CITY OF ALBUQUERQUE

**RE: Lot 16 Block 2 Unit SAD 227
6916 Rimrock NW
Grading and Drainage Plan
Engineers Stamp Date 7/2/2020 (D10D013)
Pad Certification Date 7/9/2020**

DRAINAGE AND TRANSPORTATION INFORMATION SHEET (REV 6/2018)

Project Title: 6916 RIM ROCK **Building Permit #:** _____ **Hydrology File #:** D10D013
DRB#: _____ **EPC#:** _____ **Work Order#:** _____
Legal Description: LOT 16, BLOCK 2 UNSER CLIFFS
City Address: 6916 RIM ROCK

ENGINEER'S SEAL 7/2/20 6/20/18 DAVID SOULE P.E. #14522	LOT 16, BLOCK 2 UNSER CLIFFS SUBDIVISION	DRAWN BY DEM
	GRADING AND DRAINAGE PLAN	DATE JUNE 2018
	 1608 CENTRAL AVENUE SE SUITE 201 ALBUQUERQUE, NM 87106 (505) 972-0899	LOT 16 BL 2 UNSER CLIFFS GAO
		SHEET # C1
		JOB #

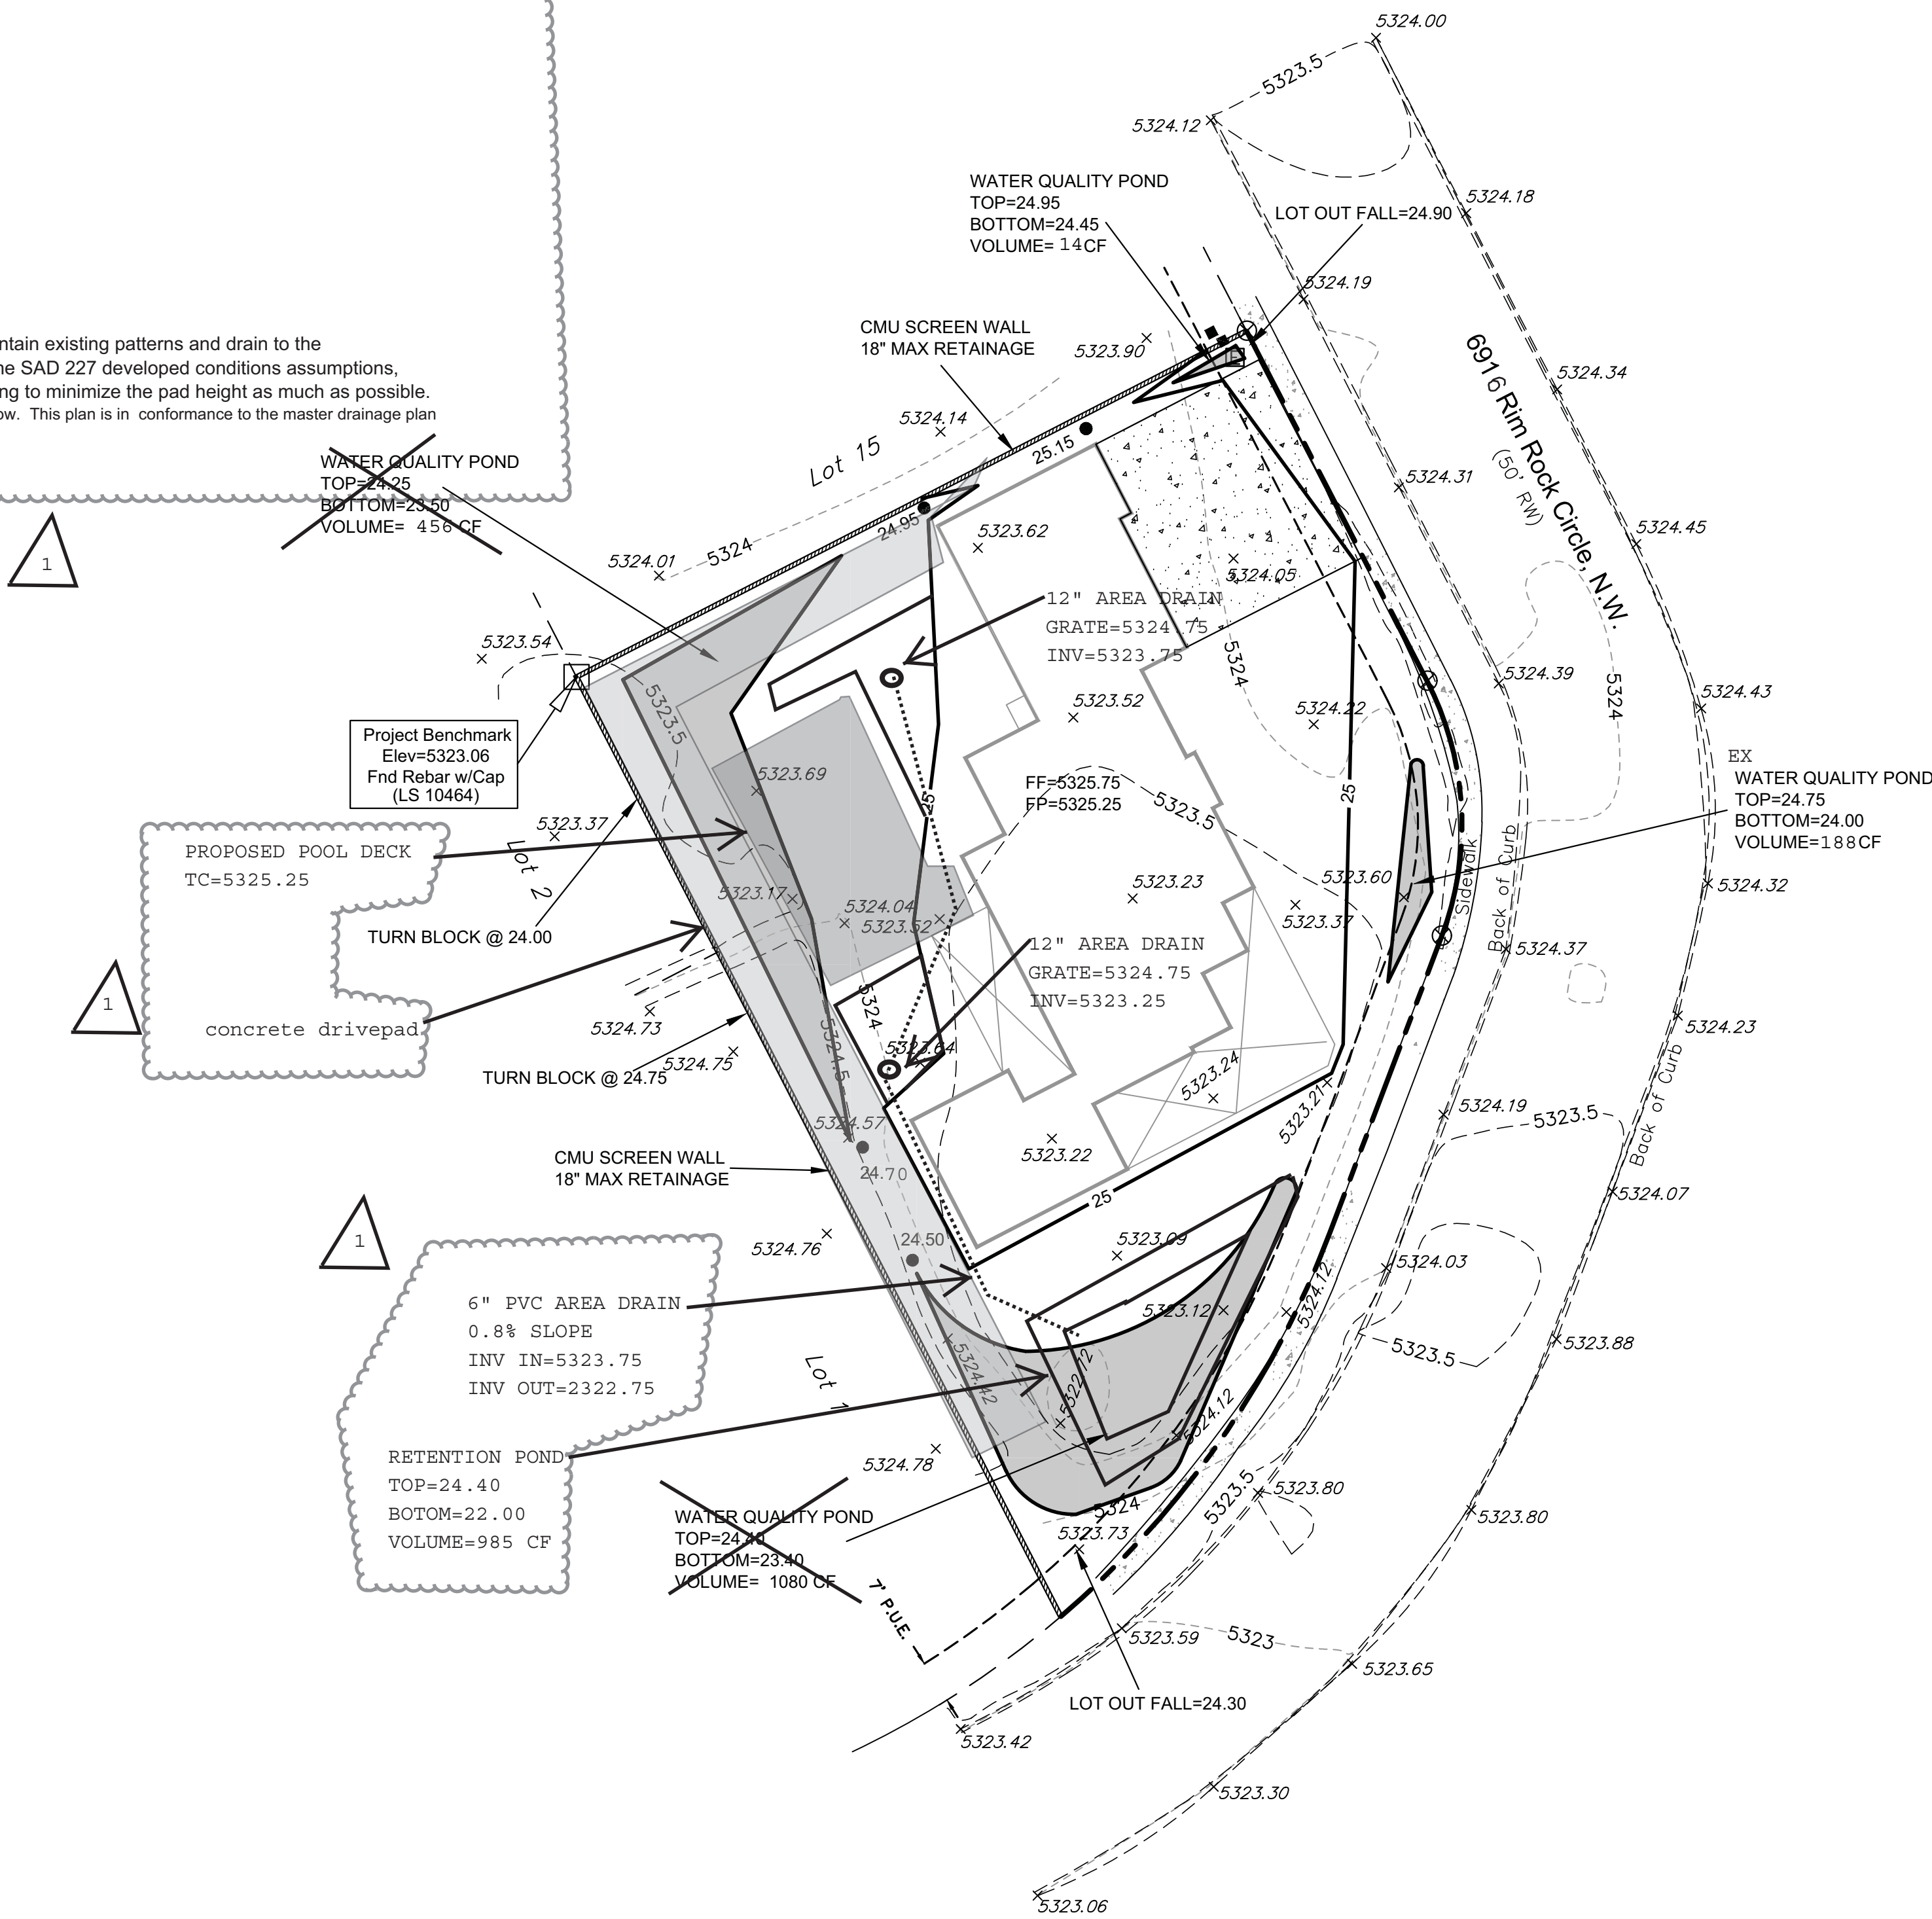
Based upon the information provided in your submittal received 4/6/2020, this plan is approved for Building Permit.

Reiterate to the Owner/Contractor that a separate permit for a garden/retaining wall must be obtained, with the approved G&D plan.

Prior to Certificate of Occupancy release, Engineer Certification per the DPM checklist of this plan will be required.
